FINAL DECISION DOCUMENT FOR THE NORTH BOUNDARY SYSTEM IMPROVEMENTS, INTERIM RESPONSE ACTION AT THE ROCKY MOUNTAIN ARSENAL

**Final Decision Document
for the North Boundary System
Improvements Interim Response Action
at the Rocky Mountain Arsenal**

COMMENTS ON THE PROPOSED DECISION DOCUMENT FOR THE
NORTH BOUNDARY SYSTEM IMPROVEMENTS INTERIM RESPONSE ACTION
JANUARY 1989

SHELL OIL COMMENTS
ON THE
PROPOSED DECISION DOCUMENT FOR THE NORTH BOUNDARY
SYSTEM IMPROVEMENTS INTERIM RESPONSE ACTION, JANUARY 1989

Figure 3. Generalized Alluvial Groundwater Flow Across RMA
 (NOTE: Arrows are indicative of direction of flow and do not represent flow quantities.)

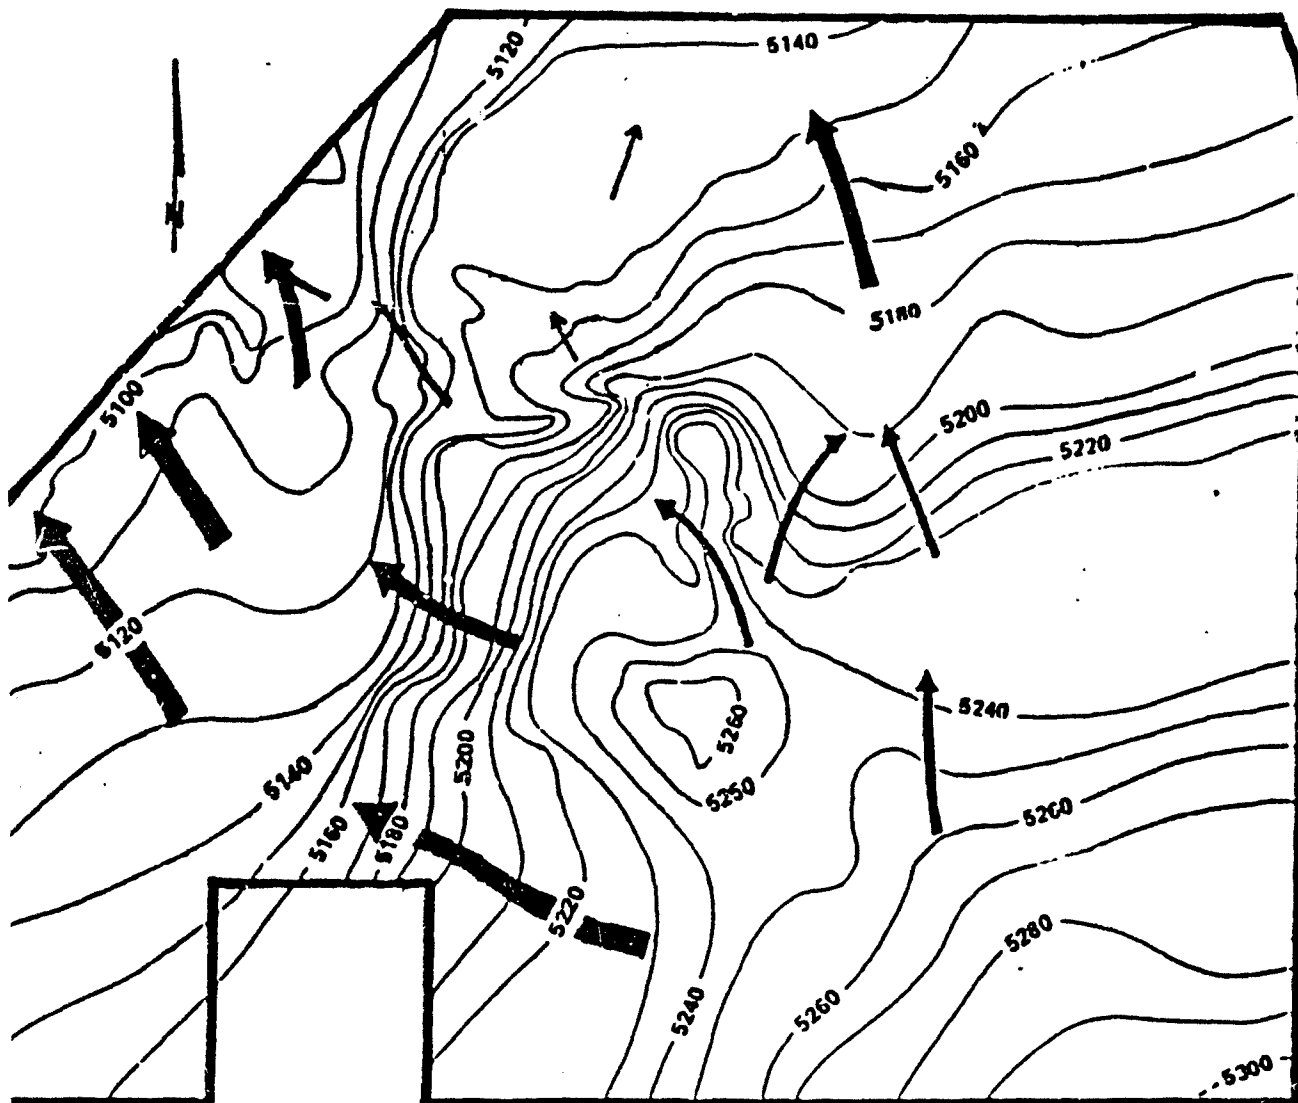
2. Page 5, Figure 3.

The arrows representing flow towards the northern Arsenal boundary incorrectly imply that the groundwater flow from the vicinity of Basin F is similar in magnitude to the groundwater from the vicinity of First Creek. The groundwater flow from the First Creek vicinity is much greater than the flow from the vicinity of Basin F. The arrow roughly in vicinity of Basin C and Basin F is also disproportionately large. In fact, recent hydro!ogeological investigations in this area provide evidence that this flow is almost nonexistent. Replacing this entire figure with a figure showing more up-to-date information is recommended.

RESPONSE: The arrows on Figure 3 have been reduced in size to de-emphasize the flows north of Basin F and from the vicinity of Basin C. The referenced source has been deleted. A note has been added to indicate that arrows are indicative of direction of flow and do not represent flow quantities.
